**STAFF REPORT
WEST ALLIS PLAN COMMISSION
Wednesday,
June 24, 2026 Room 128, 6:00 PM**

2. Site, Landscaping, and Architectural Design Review for Storage Five West Allis, a proposed Light Industrial use, at 7840 W. Hicks St. (Tax Key No. 477-0142-000)

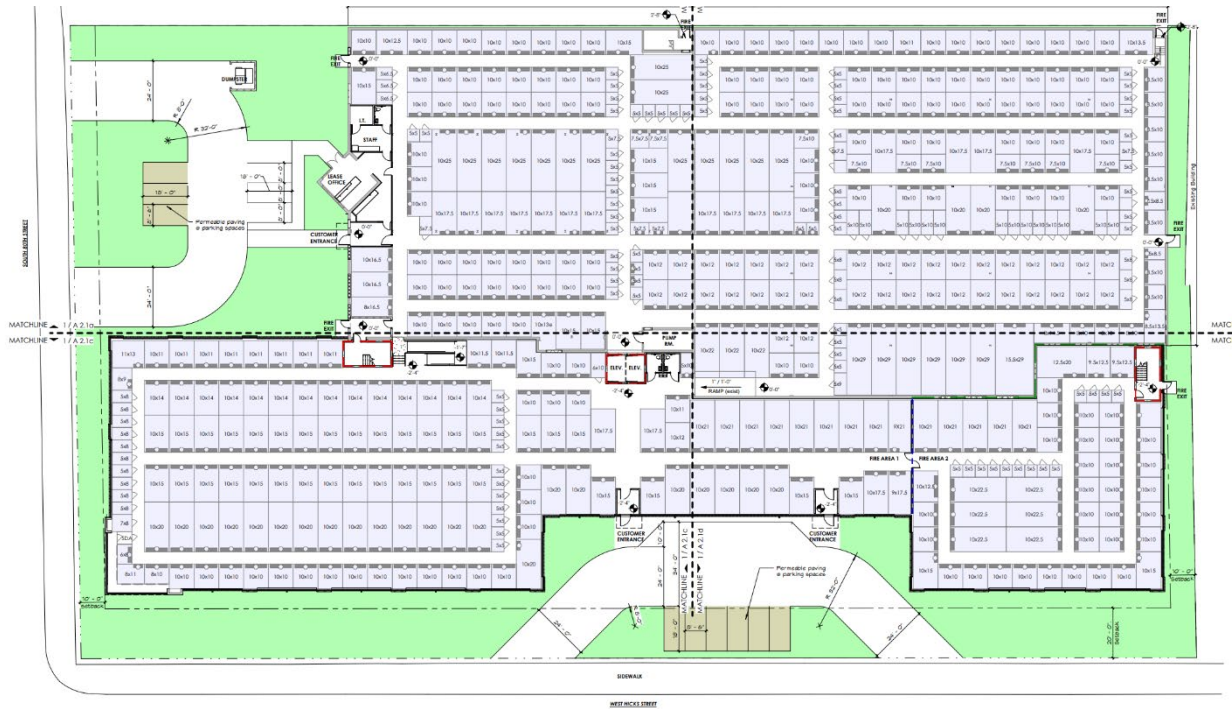
Site access is given off of both Hicks St and 80th St through a total of 4 driveways leading into two semi-circular drives. These semi-circular drives lead different entrances for the storage facility. Connected to these drives are parking areas. The total parking on site is 11 stalls, well below the maximum allowed. No bicycle racks were shown on the proposed plans. Per the gross square footage of the building, 10 bike racks are required. It is recommended that the bicycle racks are separated between the west and south entrances of the proposed facility.

Per Zoning Code regulations, a minimum of 20% of the lot is required to be landscaped/permeable for the Light Industrial use to be permitted. The project area is 114,426 sq. ft., which requires approximately 22,452 sq. ft. of landscaped/permeable area. The plans show the existing pervious area increasing from 7,900 sq. ft. to 22,452 sq. ft. through a combination of landscaping and permeable paving. This results in no net increase in total impervious area and satisfies the 20% minimum requirement.

The landscaping shown on the site primarily functions to aesthetically soften the building. A variety of bushes and shrubs line the perimeter of the public facing portions of the building. Additionally, the two permeable parking areas near the semi-circular driveways both are screened with shrubs and trees. The refuse area on site is also screened with trees in addition to fencing.

1. All required [building](#), [occupancy](#), [stormwater](#), and related permits shall be obtained prior to commencing work or occupying the facility.
2. Submittal of revised plans to the Planning & Zoning office showing the required bicycle parking spaces for 10 bicycles, preferably split between the west and south customer entrances where practical.
3. Final signage shall require separate review and approval through the sign permit process and shall comply with all applicable location, size, illumination, and design standards.
4. Final site, civil, landscaping, architectural, lighting, stormwater checklist, and utility plans shall be submitted for review and approval by the applicable City departments prior to permit issuance.
5. The applicant shall coordinate construction staging details with City staff and any complete any [drive-way and right-of-way permits](#).

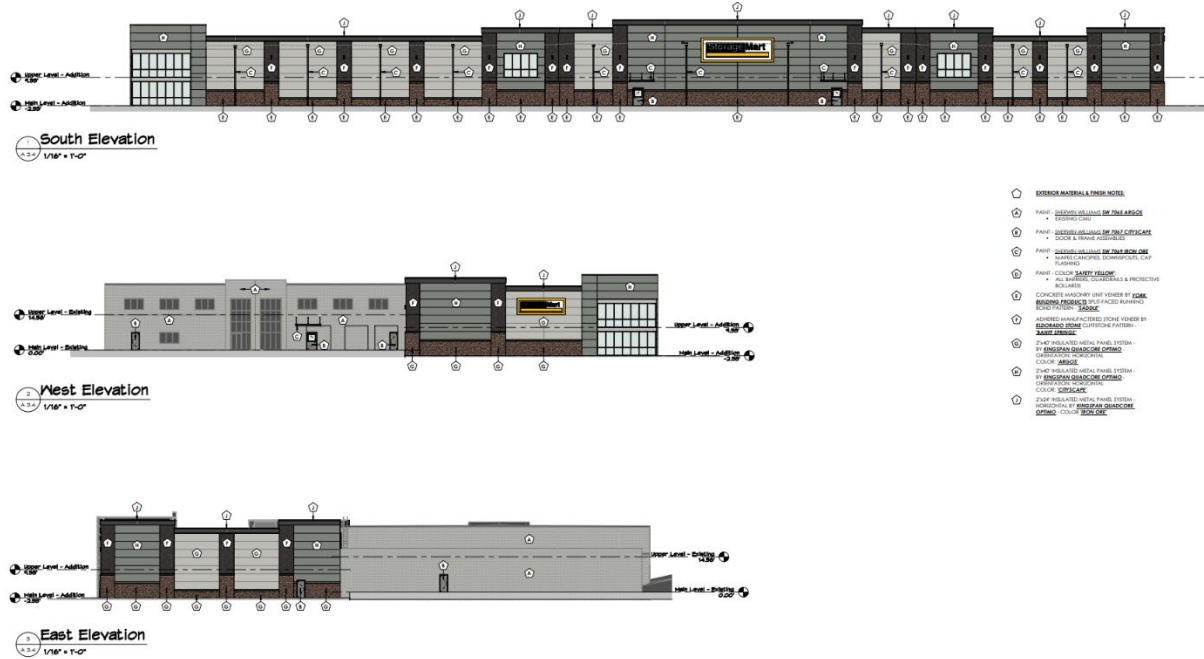
The submitted architectural elevations show a substantial exterior renovation of the existing industrial building and the construction of a new two-story addition. The updated plans include exterior material and finish notes, including painted existing CMU, painted door and frame assemblies, painted accessory items such as exposed gutters/downspouts and cap flashing, concrete masonry unit veneer, adhered manufactured stone veneer, and insulated metal panel systems in coordinated gray tones. The south elevation, which is the primary elevation visible from W. Hicks St., includes the greatest level of architectural treatment, with storefront-style glazing, brick/stone base elements, vertical masonry accents, horizontal metal paneling, varied parapet heights, entrance canopies, and wall plane/material changes to reduce the appearance of a long industrial façade.

The west elevation includes similar treatment near the customer entrance and addition, while portions of the existing building remain more utilitarian in appearance. The north and east elevations are less detailed and appear to retain existing wall area, which is less visible from the primary public frontages but should still be maintained in a finished condition.

Staff notes that signage is shown on the elevations for general design intent. Final sign location, size, illumination, color, and style will require separate review through the sign permit process. Given the residential properties across W. Hicks St., staff recommends that final signage and

lighting be reviewed to ensure compliance with City standards and to limit unnecessary glare or visual impacts toward nearby residences.
